This sheet transmits Revision 1 to MTB-34-03, which:

NAVIGATION - TDR-94D ATC TRANSPONDER STRAPPING CHANGE FOR KING AIR B300 AND B300C CONFIGURED FOR 15,500 OR GREATER MAX TAKEOFF WEIGHT

To correct the ADS-B Out emitter category from Light to Small on ADS-B Out capable airplanes configured for 15,500 or greater MTOW.

MTB-34-03  
Page 1 of 12

Figure 2. Transponder Wiring Modification, Before and After (Sheet 1)

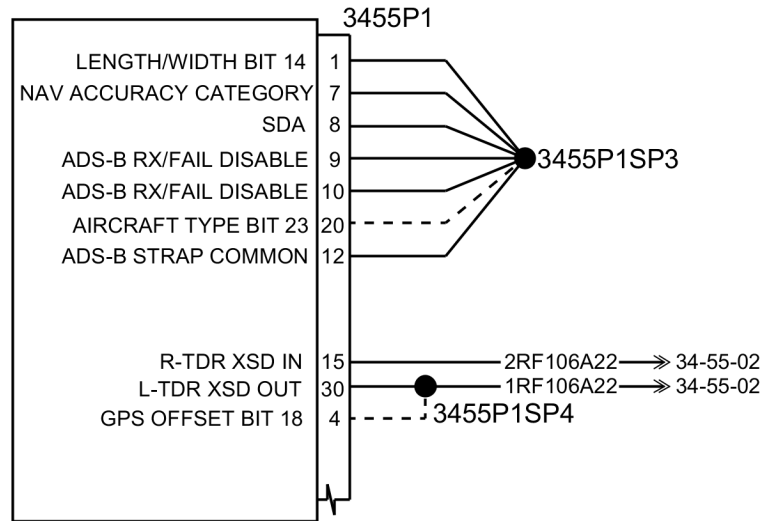
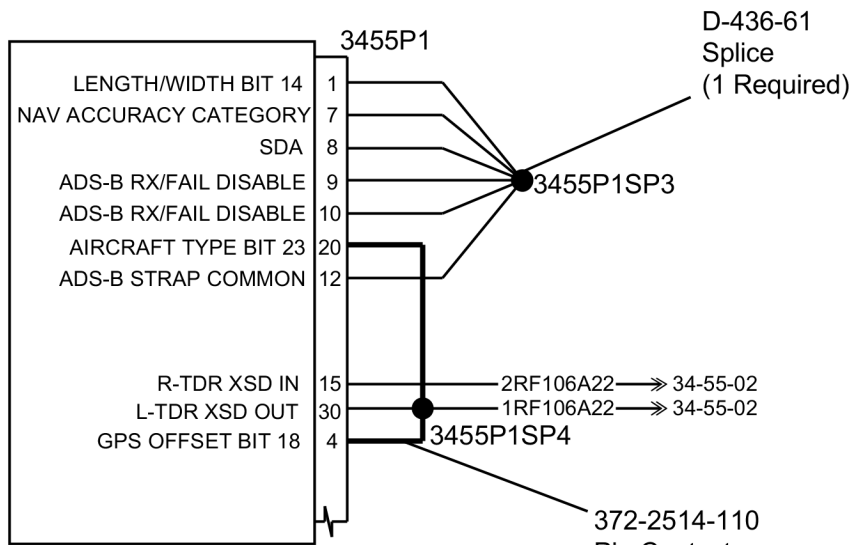
- A. (Refer to Figure 2, Sheet 1, Before Modification.) Remove the jumper wire from Connector 3455P1 Pin 20 and 3455P1SP3.
- B. (Refer to Figure 2, Sheet 1, Before Modification.) Remove the jumper wire from Connector 3455P1 Pin 4 and 3455P1SP4.
- C. (Refer to Figure 2, Sheet 2, Before Modification.) Remove the jumper wire from Connector 3455P5 Pin 20 and 3455P5SP5.
- D. (Refer to Figure 2, Sheet 2, Before Modification.) Remove the jumper wire from Connector 3455P5 Pin 4 and 3455P5SP6.
- E. Fabricate four jumper wires with 131681AJ22-9 Wire and four 372-2514-110 Pin Contacts, one pin contact on each jumper wire.

**NOTE:** The jumper wires will only need to be about six inches long.
- F. (Refer to Figure 2, Sheet 1, After Modification.) Install one fabricated jumper to Pin 20 on Connector 3455P1.
- G. (Refer to Figure 2, Sheet 1, After Modification.) Install one fabricated jumper to Pin 4 on Connector 3455P1.
- H. (Refer to Figure 2, Sheet 1, After Modification.) Splice the two installed jumpers and the existing wires from Pin 30 at 3455P1SP4 with one M81824/1-2 Splice.
- I. (Refer to Figure 2, Sheet 1, After Modification.) Splice the wires at 3455P1SP3 with one D-436-61 Splice.
- J. (Refer to Figure 2, Sheet 2, After Modification.) Install one fabricated jumper to Pin 20 on Connector 3455P5.
- K. (Refer to Figure 2, Sheet 2, After Modification.) Install one fabricated jumper to Pin 4 on Connector 3455P5.

Figure 2. Transponder Wiring Modification, Before and After (Sheet 2)

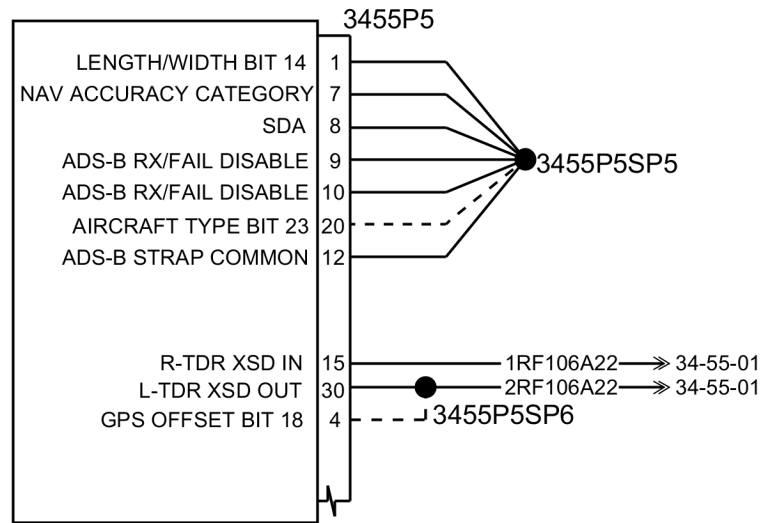
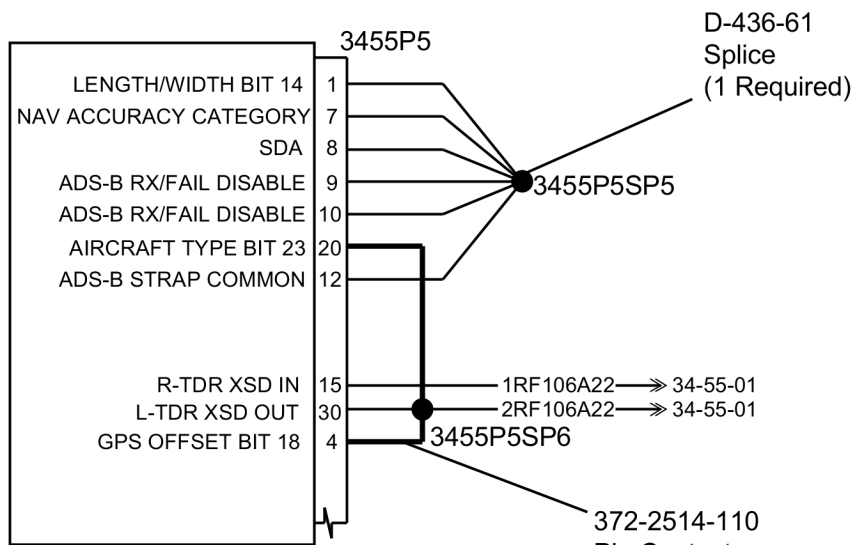
- L. (Refer to Figure 2, Sheet 2, After Modification.) Splice the two installed jumpers and the existing wires from Pin 30 at 3455P5SP6 with one M81824/1-2 Splice.

- M. (Refer to Figure 2, Sheet 2, After Modification.) Splice the wires at 3455P5SP5 with one D-436-61 Splice.
4. Install the No. 1 and No. 2 transponders. (Refer to the applicable Model Maintenance Manual for transponder installation.)
